REVISED RESPONSE TO REQUEST FOR ADDITIONAL INFORMATION

APR1400 Design Certification

Docket No. 52-046

RAI No.: 132-8088

Figure 11.5-2X Location of Radiation Monitors at Plant (CCW HX Building El. 113'-0" and 127'-5")

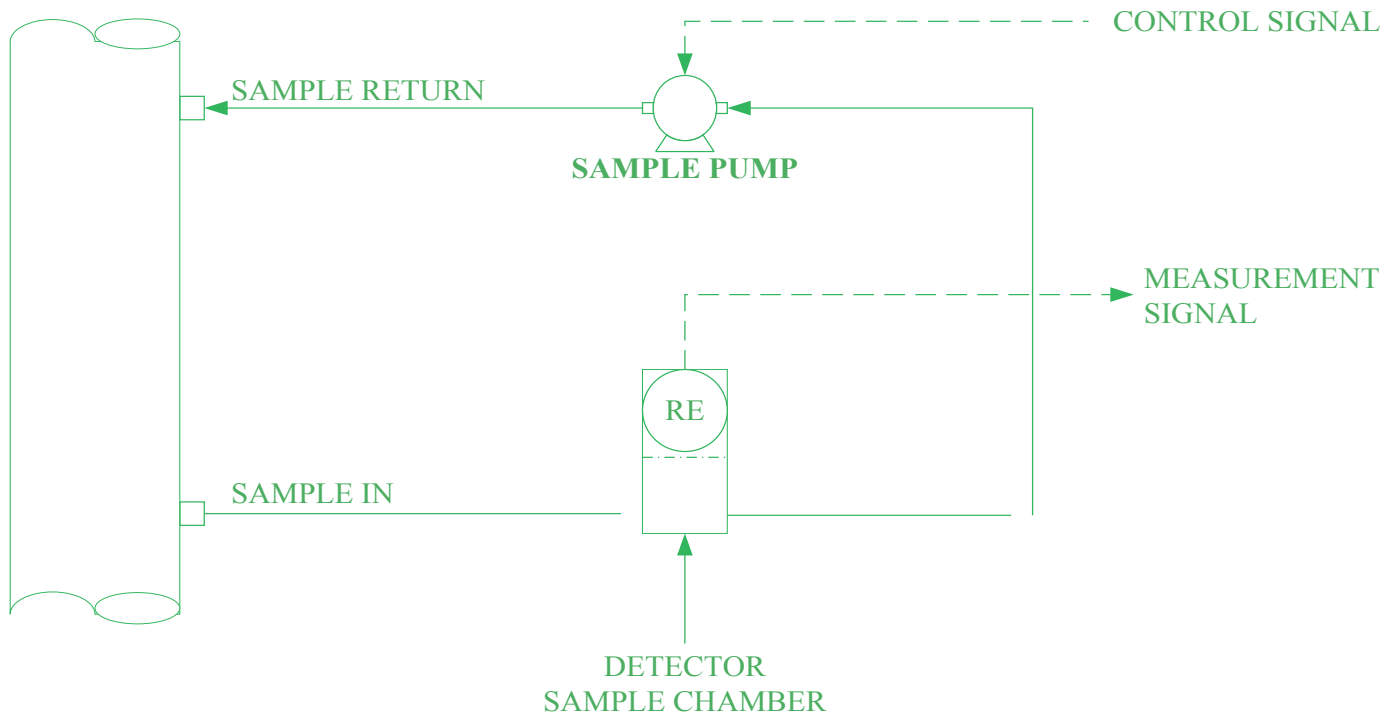
Information contained in DCD section 11.5.2.3 does not include the level of detail SRP section 11.5 details in the description for the PERMSS. Inspection of Tier 1 Section 2.7.6.4 the staff observes that there are indications not described in Section 11.5 that are seen in Tier 1 Table 2.7.6.4-1. This Tier 1 table has a column to describe if there is a Display/Alarm in the MCR/ or RSR indication. Each detector in this table has a "Yes" marked down for all three indications, however DCD Section 11.5 does not fully include a description of all indications in either the text or DCD Tables 11.5-2.

- Each monitor should contain a discussion on its specific location

The liquid PERMSS monitors listed in Table 11.5-2 have been thoroughly reviewed to correct the discrepancies and omissions of the monitor location.

Figures 11.5-2 will be revised to show the correct location of the radiation detectors (RE) and the monitor electronics/displays (RT). In the figures, RE/RT means that the detector and electronic/display are installed together adjacent to each other. The location of some RE and RT have been changed to the correct location. Subsection 11.5.2.3.5 will be added to describe that the location of each monitor is shown in Figures 11.5-2.

The monitors are located in CCW HX Building as shown in Figure 11.5-2X.
